Access Compliance Report

Public Rights-of-Way

(Pedestrian Signals)

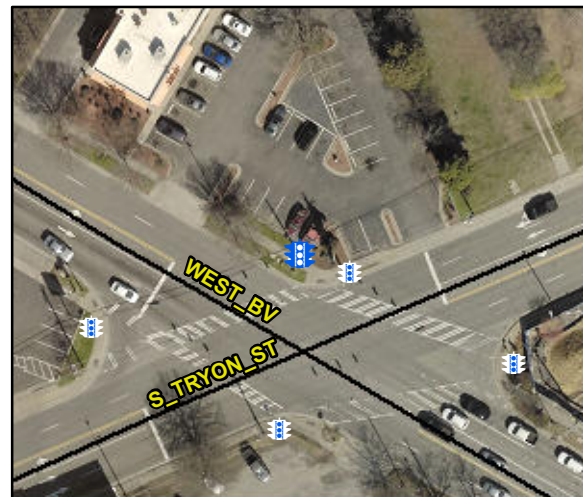
PROW/ADA: TMUTCD 4e.08, R404.3, R404.2

Possible Solutions: Replace Signal Push Button With APS Button on New Post. Remove & Relocate Sign.
